Regulation No. 94

**UNIFORM PROVISIONS CONCERNING THE APPROVAL OF VEHICLES WITH
REGARD TO THE PROTECTION OF THE OCCUPANTS IN THE EVENT OF A
FRONTAL COLLISION,
AND THE PROTECTION OF THE OCCUPANTS OF VEHICLES OPERATING ON
ELECTRIC POWER FROM HIGH VOLTAGE AND ELECTROLYTE SPILLAGE AFTER
A FRONTAL COLLISION**

Proposal for draft amendments to Regulation No. 94- Rev. 1

The text reproduced below was prepared by ??? in order to extend the scope of the present Regulation to all kinds of power train systems above a certain working voltage level. The modifications to the existing text of the Regulation R 94 are based on discussions made at [the ELSA adhoc group meeting held in Paris at 22-23 October 2009, and on a working document ECE/Trans/WP.29/GRSP/2009/16 distributed as a document without symbol (informal document No. GRSP-45-03) during the forty-fifth session of the Working Party on Passive Safety (GRSP). The modifications to the existing text of Regulation No. 94 are marked in bold or strikethrough characters].

Figure 23: Measurement of V_1'

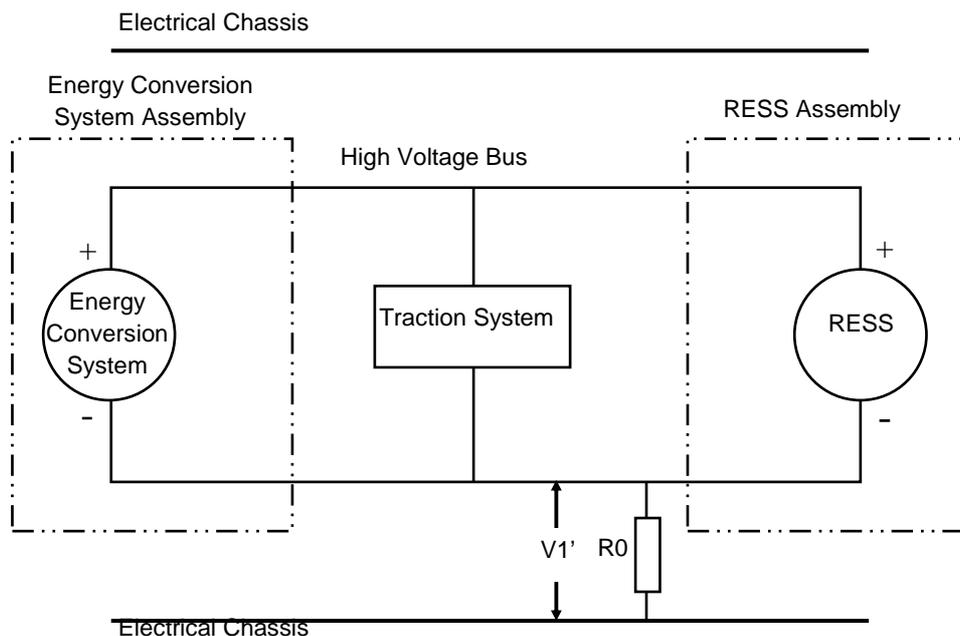
If V_1 is greater than or equal to V_2 , insert a standard known resistance (R_0) between the negative side of the high voltage bus and the electrical chassis. With R_0 installed, measure the voltage (V_1') between the negative side of the high voltage bus and the vehicle electrical chassis (see Figure 2). Calculate the isolation resistance (R_i) according to the formula shown. Divide this electrical isolation resistance value (in Ω) by the working voltage of the high voltage bus (in volts).

$$R_i = R_0 \cdot (V_b / V_1' - V_b / V_1) \quad \text{or} \quad R_i = R_0 \cdot V_b \cdot (1 / V_1' - 1 / V_1)$$

Figure 3: Measurement of V_2'

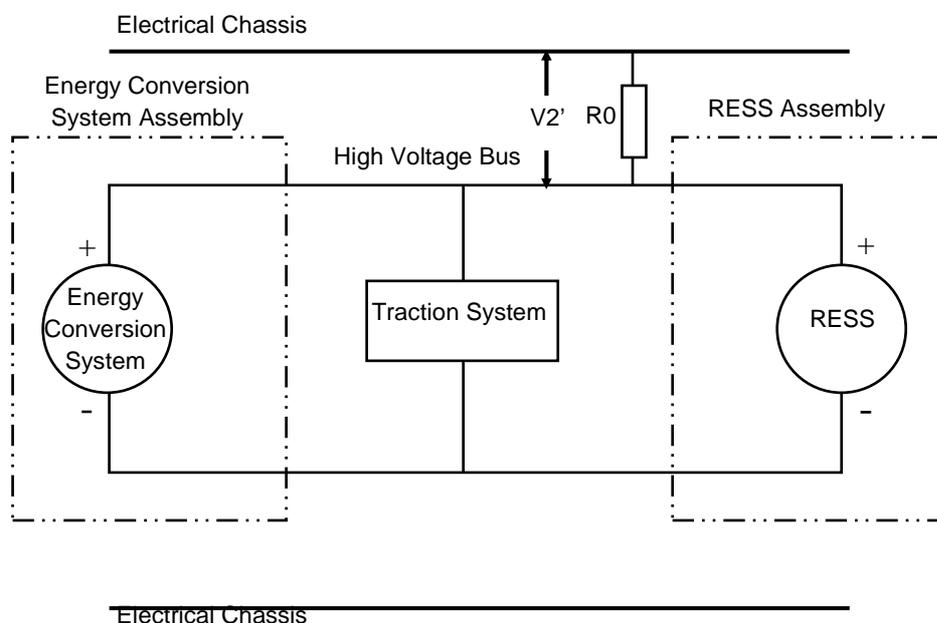
If V_2 is greater than V_1 , insert a standard known resistance (R_0) between the positive side of the high voltage bus and the electrical chassis. With R_0 installed, measure the voltage (V_2') between the positive side of the high voltage bus and the electrical chassis (See Figure 3).

NOTE 1: The standard known resistance R_0 (in Ω) should be approximately 500 times the working voltage of the vehicle (in volts). R_0 is not required to be precisely this value since the equations are valid for any R_0 ; however, an R_0 value in this range should provide good resolution for the voltage measurements.

Comment: "Note" is not appropriate for regulations. Move to footnote?

$$R_i = R_0 \cdot (V_b / V_2' - V_b / V_2) \quad \text{or} \quad R_i = R_0 \cdot V_b \cdot (1 / V_2' - 1 / V_2)$$

Figure 4: Measurement of high voltage bus energy

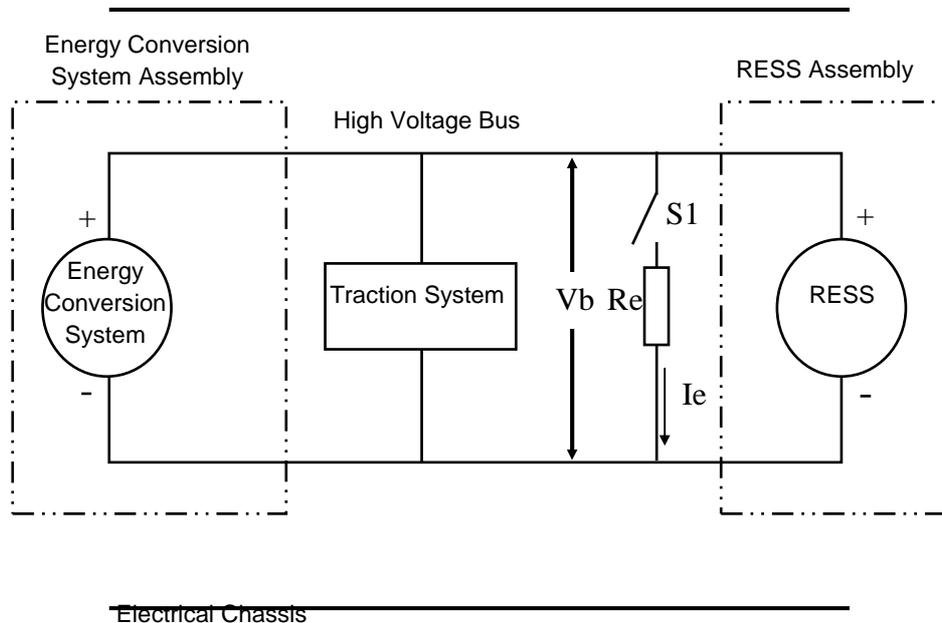
After the vehicle crash determine the high voltage bus energy (see Figure 4). Install switch S1 and known resistance Re. Close switch S1 and measure and record voltage Vb and current Ie. [Integrate the product of these two measurements with respect to time as shown below to obtain total energy.]

t₀ = ???
 t₁ = ???

$$\int_{t_0}^{t_1} V_b \times I_e dt$$
